City of Hapeville

Design Review Committee

April 17, 2019

PLANNER'S REPORT

3121 HOPE ST (FROND DRIVE WAY PROJECT (PHASE 1)

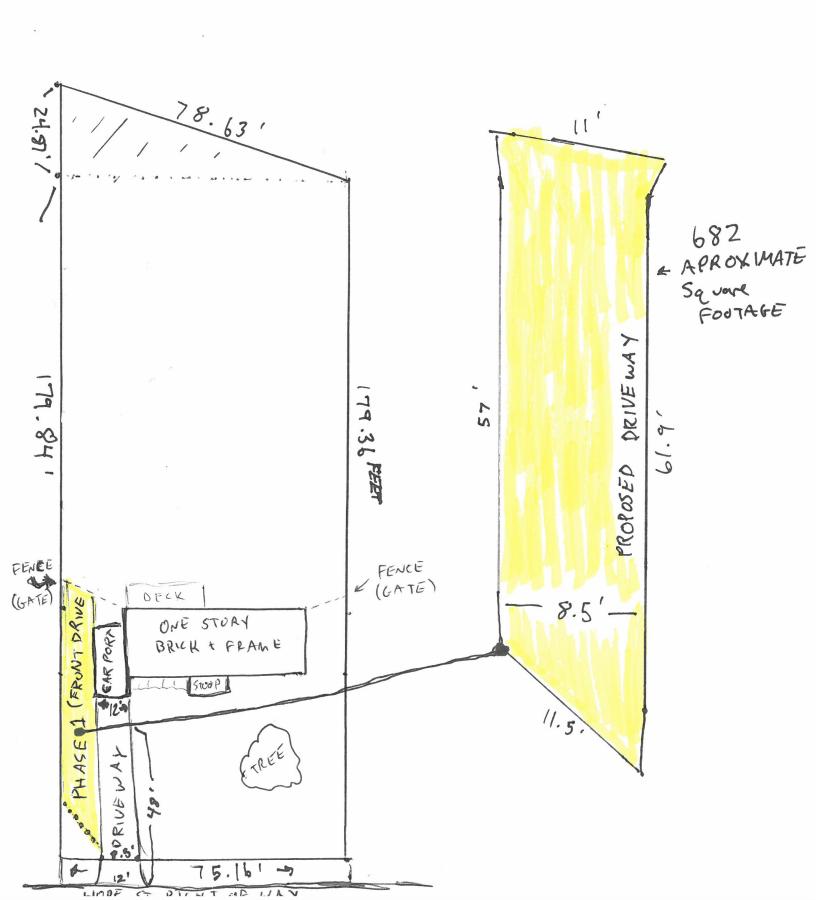
The proposed driveway will be 20.5' at its widest point, which will require a design exception.

Scope of construction does not include modifications to the existing carport.

The intent of the expanded driveway is to allow for the eventual construction of a garage in the back yard. The extra width is necessary to allow passage around the existing carport. The driveway is not 20.5' wide for its entirety, and is only 8.5' wide at either end. Staff recommendation is to approve the design exception.

PROPOSED ELEVATION
4"=1'0"

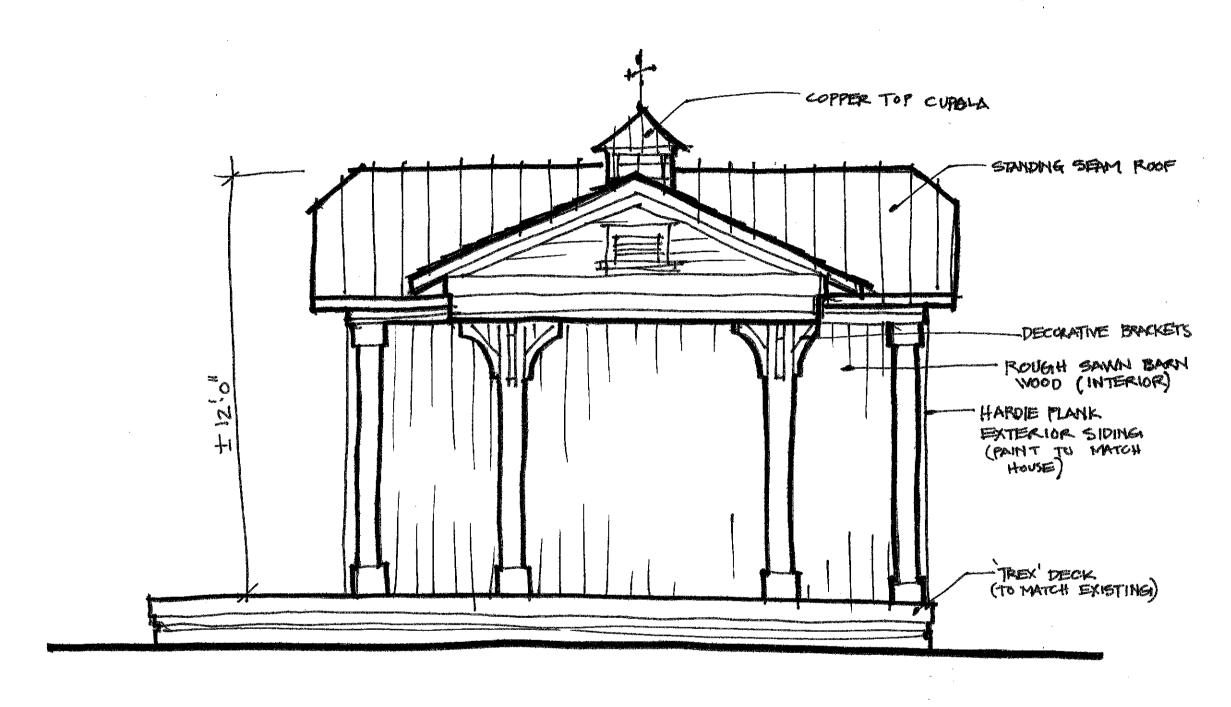
STAFF COMMENT: The metal standing seam roof is not compatible in material or architectural style with the principal building.

The Applicant should clarify the total height of the outbuilding from grade. Outbuildings must be at least 14' high.

The Applicant should clarify if there are any outbuildings on the adjacent lot within 10' of the proposed outbuilding.

Once these items are addressed to the satisfaction of Staff and/ or the Design Review Committee, the application is recommended for approval.
